Submission Details

Application Number	PT8GC231
Applicant Name	Galway County Council
Development Address	Eanach Dhúin/ Annaghdown Co. Galway

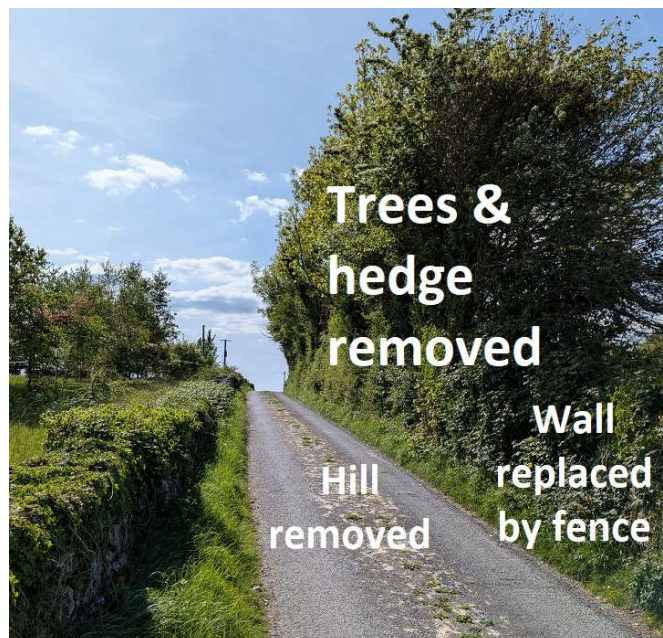
1. The entrance to the graveyard should be on the main road

The proposed design has only 1 way in and 1 way out and will be a bottleneck during burials. Having an entrance on the main road will allow traffic to get away quickly in 2 directions like the current graveyard.

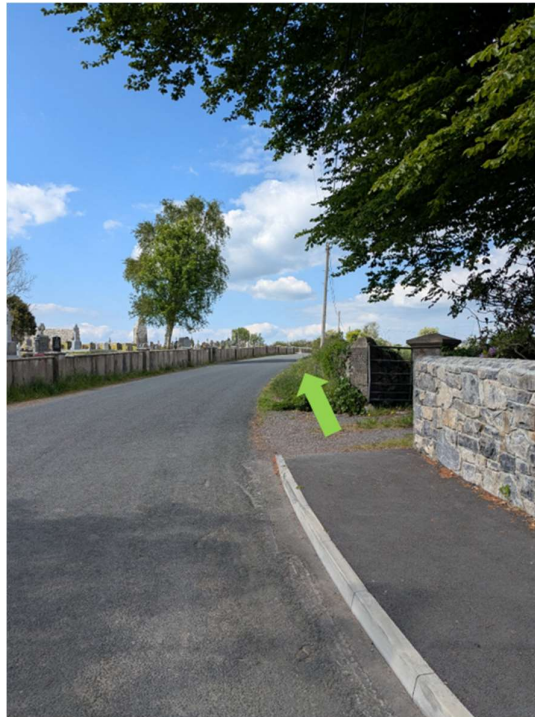
2. The council must buy the whole field

- Normal car park
A normal car park will be possible with enough spaces to get all cars attending burials in off surrounding roads.
- Space for all graves to face east to the rising sun like the current graveyard instead of the proposed half facing east & half facing west.

4. How do cars parked on the access road leave after burials?

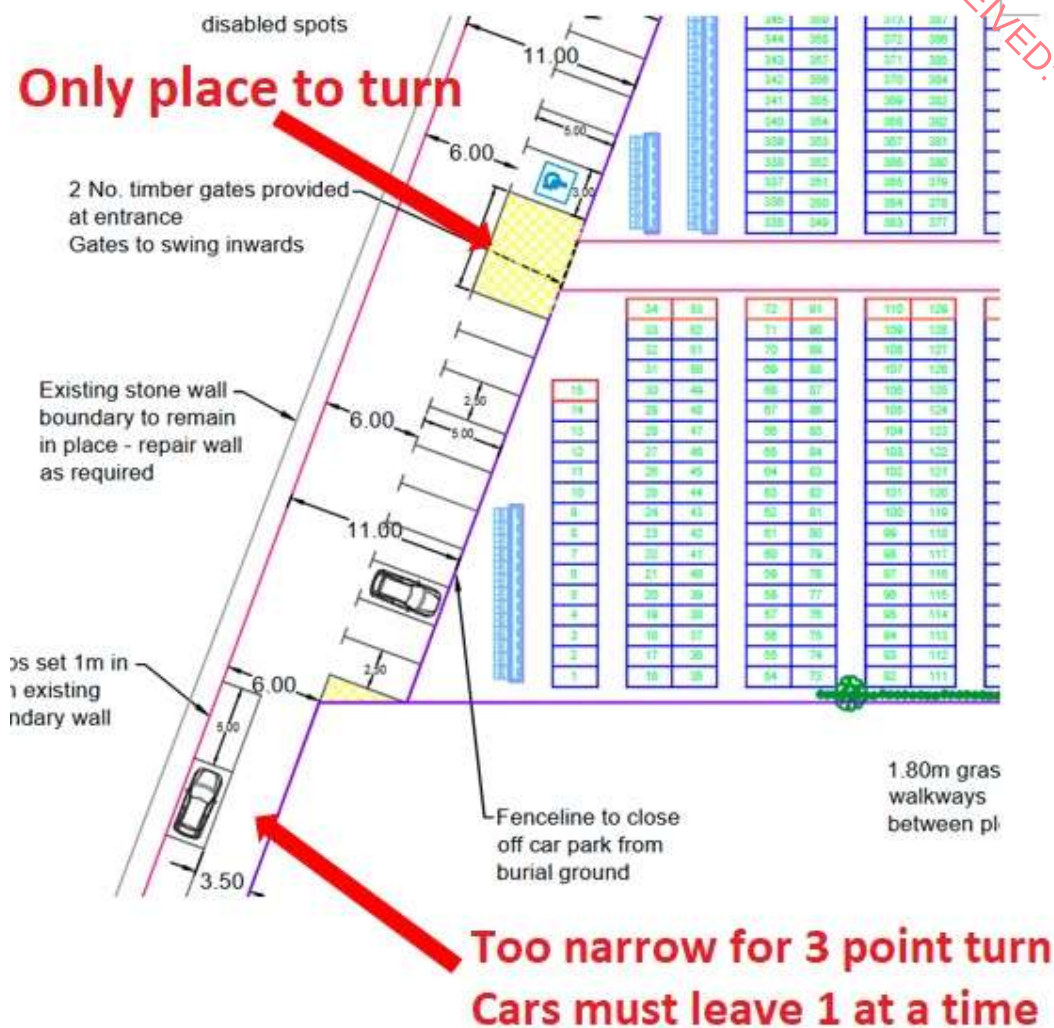
- After burials, the cars parked on the access road will leave before the family cars parked at the graveyard.
- The access road is too narrow to do a 3-point turn.
- Cars parked on the access road must drive up to the graveyard gate to turn.
- 1 car leaving blocks the access road so cars must leave 1 at a time slowing everything down.
- People looking for a discreet and efficient get away after a burial will naturally park on surrounding roads & outside houses which creates unnecessary health & safety risks.
- A normal car park on the main road cuts out all these unnecessary problems.
